Application for Development Consent

Application Reference Number: WWO10001

Examining Authority's Second Written Round of Questions and Requests for Information Response from Thames Water

Responses to second written questions Q36 Water Quality and Resources

Figure 4.1 Comparison of CSO discharges in the Shad Thames tidal reach for the four residual CSO events

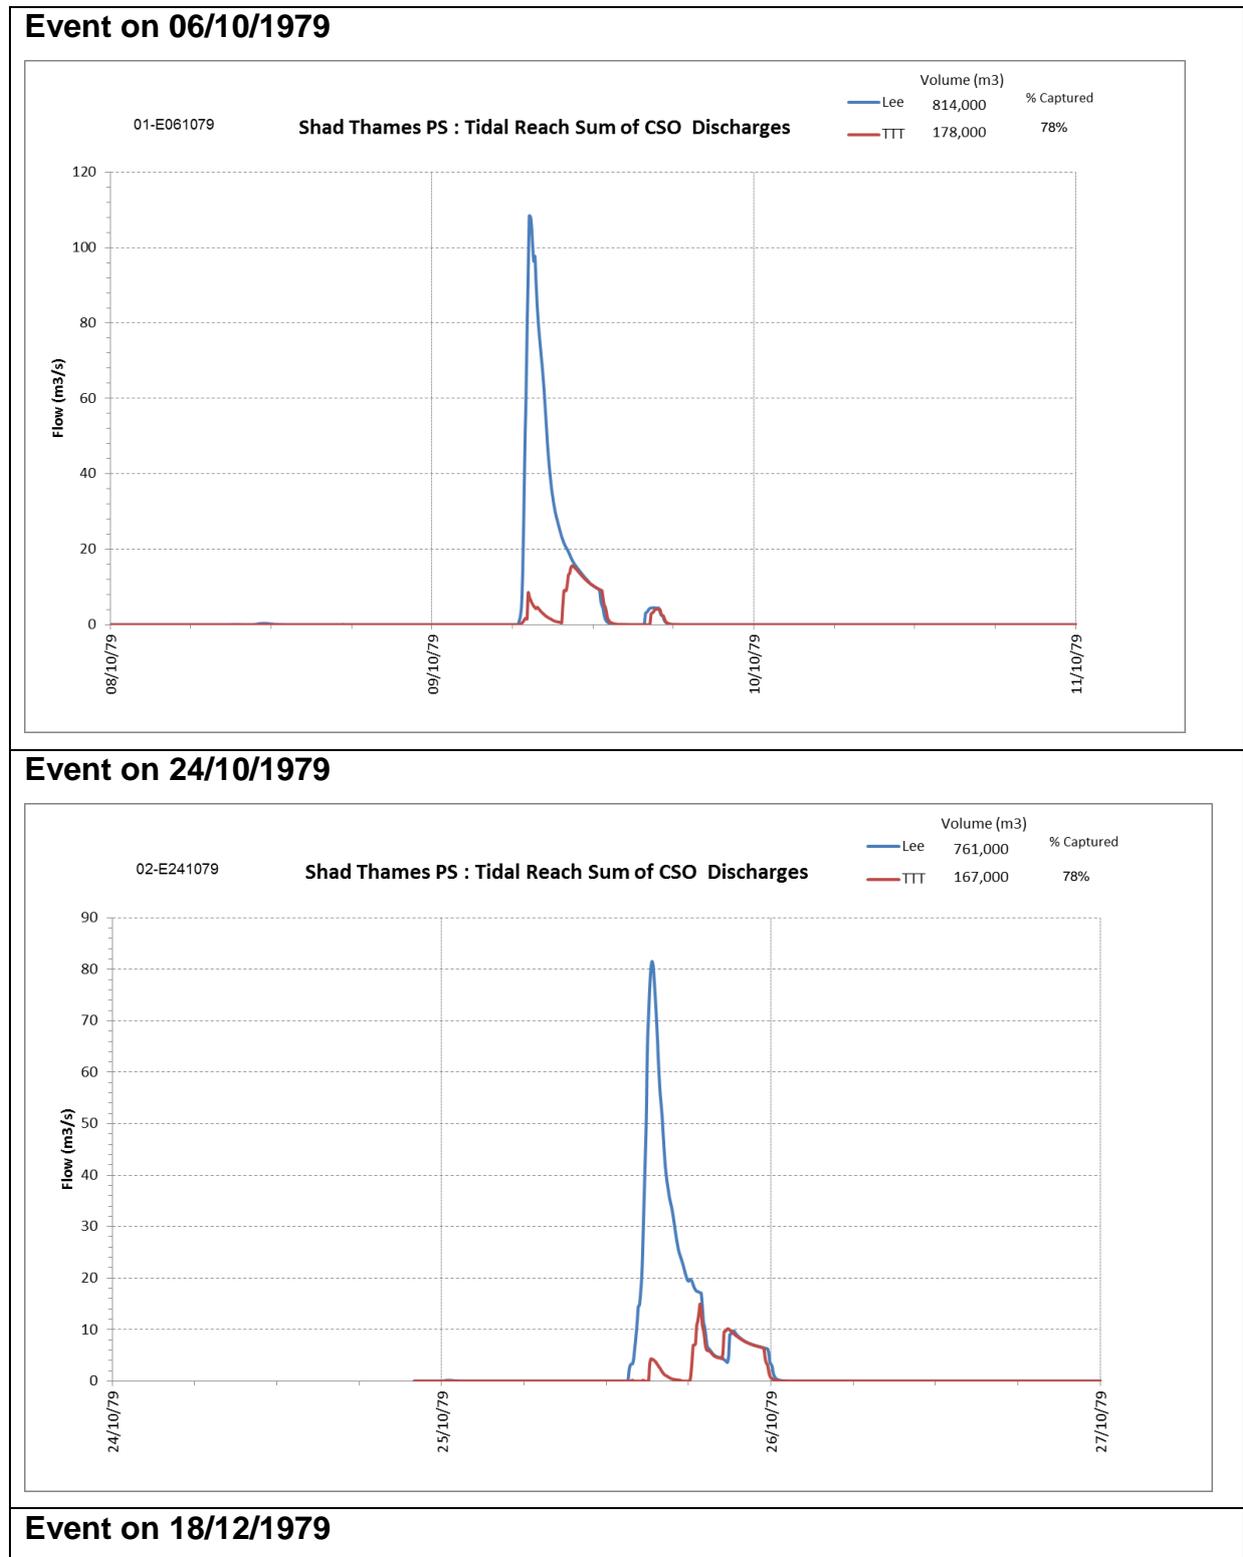
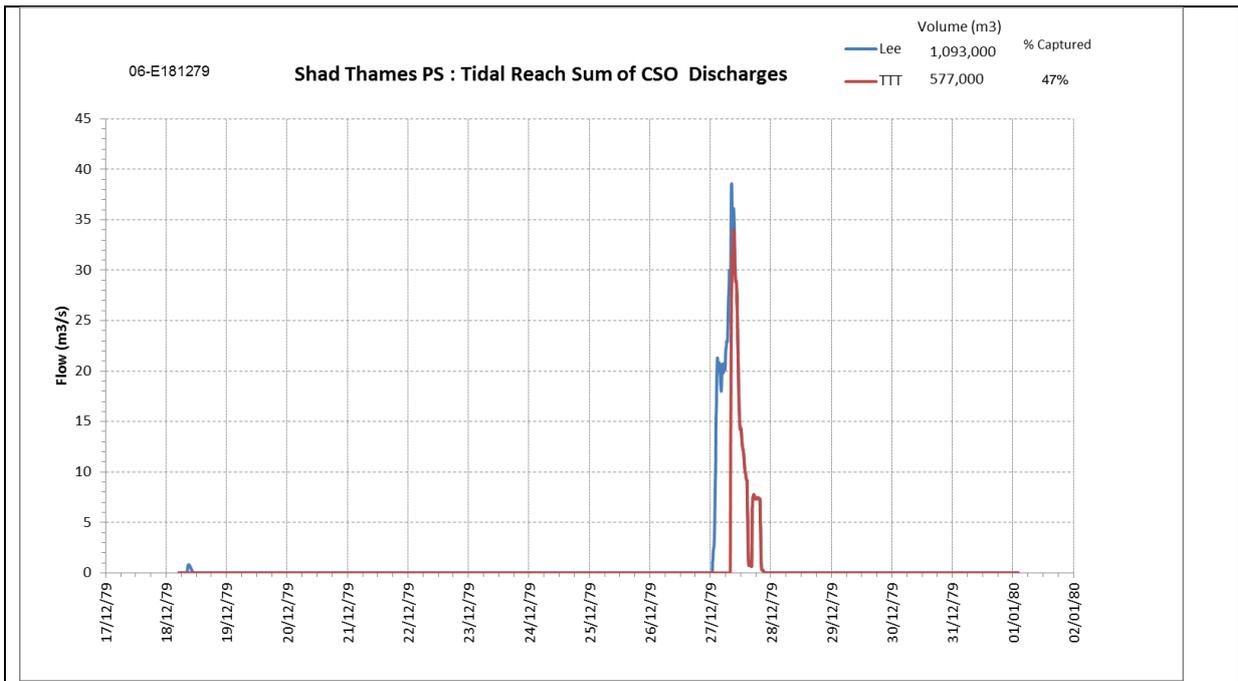
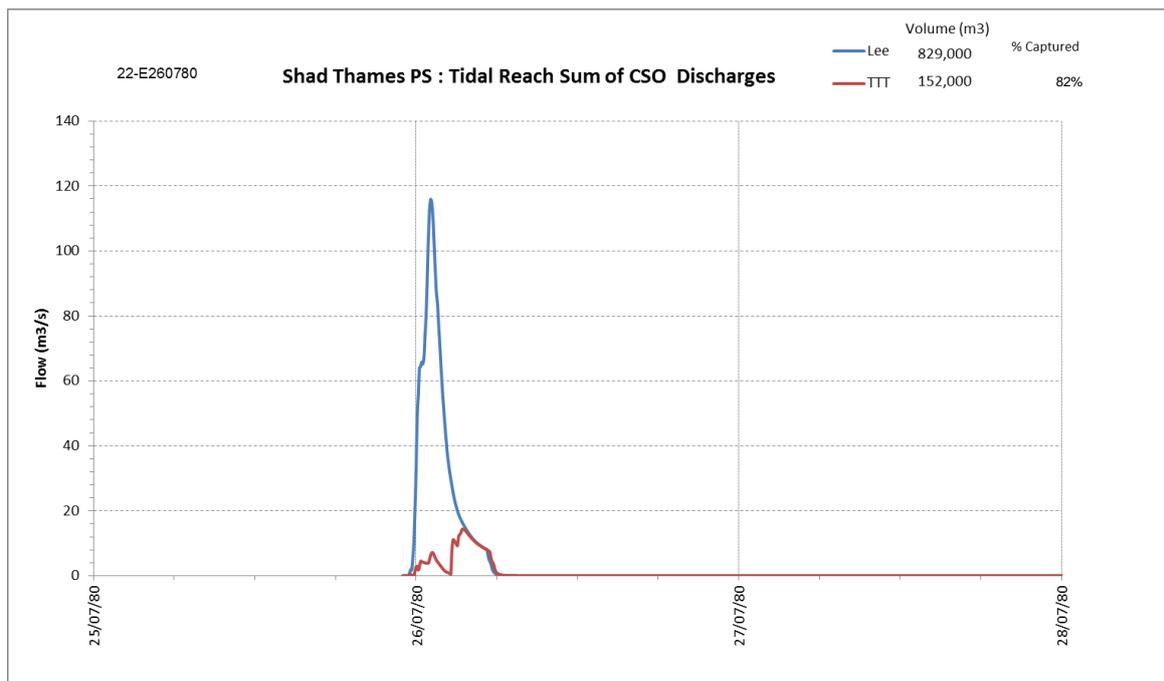
Can the EA and the Applicant explain how the reduction in flows of 28% at Shad Thames CSO would affect aesthetics, and what would be the fall back proposal in the event of the problems continuing?

- 4.1.5 Figure 4.1 shows how the tunnel system captures these CSO discharges influencing the Shad Thames tidal reach for the four residual CSO events in the typical year (ie, the discharges that would occur because the tunnel system is full). Whereas Table 4.1 shows the discharge volume captured by the main tunnel for all CSO events within the Shad Thames tidal reach.

4.1.7 Because only four discharges would occur at the unsatisfactory CSOs with the tunnel system, a high degree of aesthetic improvement is expected in this tidal reach compared to the base case, which can be affected by up to 39 discharge events from the larger adjacent CSOs. Even during the four

residual events, the main tunnel would capture a significant portion of the first flush of pollutants, as illustrated in Figure 4.1 by capturing CSO flow at the beginning of the storm event.

Figure 6.1 Typical year CSO performance along the tidal Thames

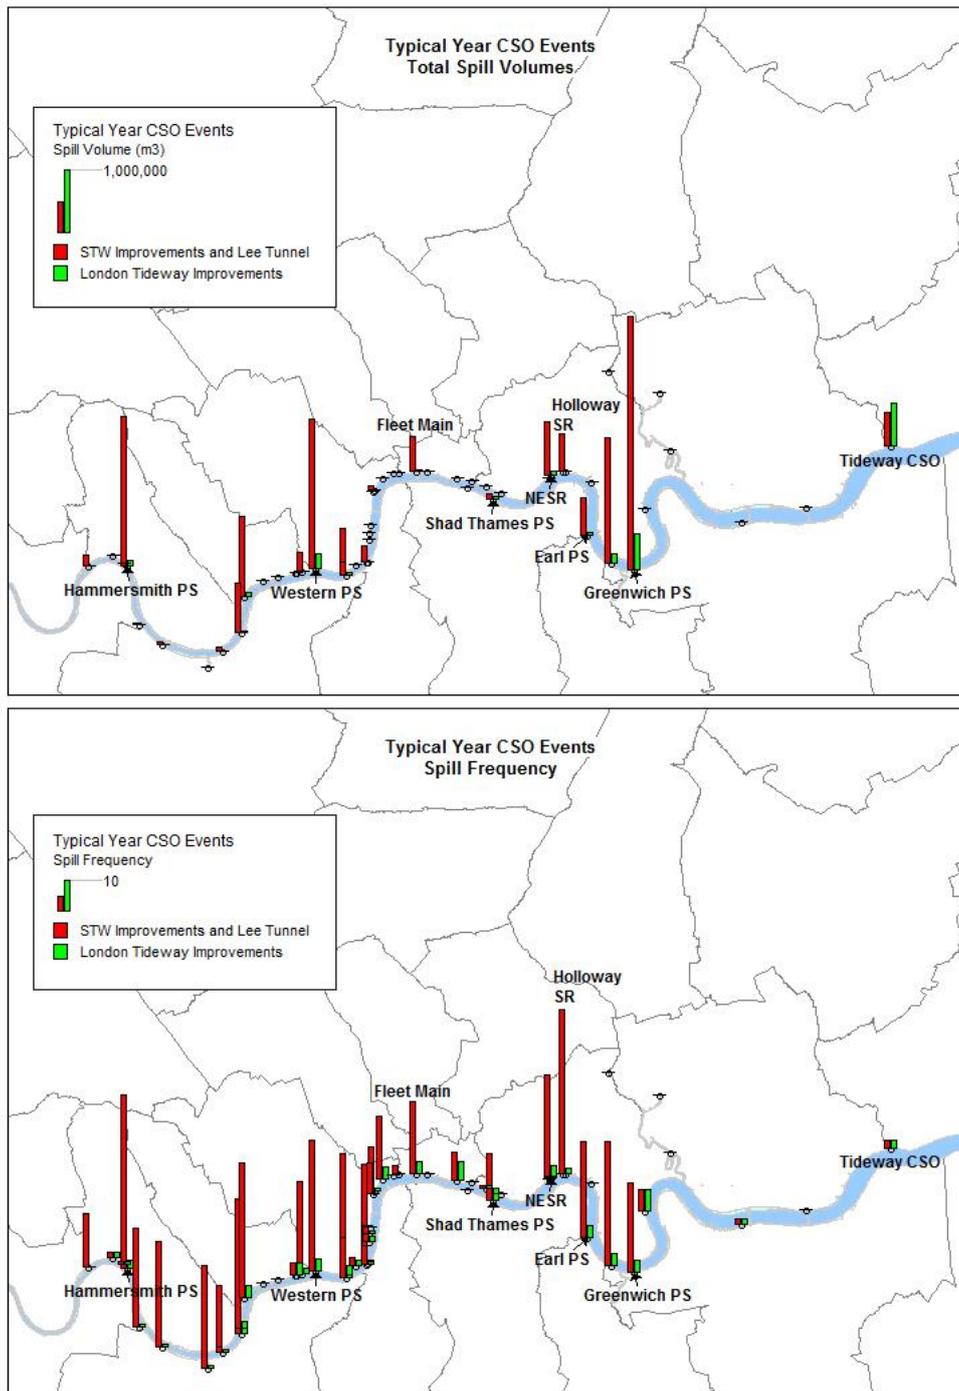
Can the Applicant comment on the matters raised in the report, insofar as they relate to the benefits of the application project upon water quality?

- 6.1.8 The reduction of Abbey Mills Pumping Station CSO discharges brought about by the Lee Tunnel has no effect on the 34 other unsatisfactory CSOs, as indicated in Figure 6.1, which shows in red the high discharge volume and frequency remaining with the STW improvements and the Lee Tunnel in place. Figure 6.1 shows in green the residual discharges with the Thames Tideway Tunnel (see also Table 1.1 in our response to second written question 36.05 for individual CSO values of frequency, durations and volumes).
- 6.1.9 Figure 6.1 also illustrates that the three discharges in the typical year from the Abbey Mills Pumping Station CSO go directly into the tidal Thames via

the new Tideway CSO totalling 35 CSO-controlled discharges to the tidal Thames. The volume of discharge in the tidal Thames remains high (approximately 18 million m³) with numerous locations continuing to discharge over 50 times per year.

- 6.1.11 Although the total volume of CSO discharges would be reduced by the STW improvements and the Lee Tunnel, the frequency, duration and volume of discharges from Acton to Greenwich would not be reduced from the existing conditions. The exceptions are Acton Storm Relief CSO, due to ongoing increases in storm tank capacity from recent capital works to improve the facilities to clean-out the tanks after storm events, and Greenwich Pumping Station CSO, due to the upgraded treatment capacity of Crossness Sewage Treatment Works.
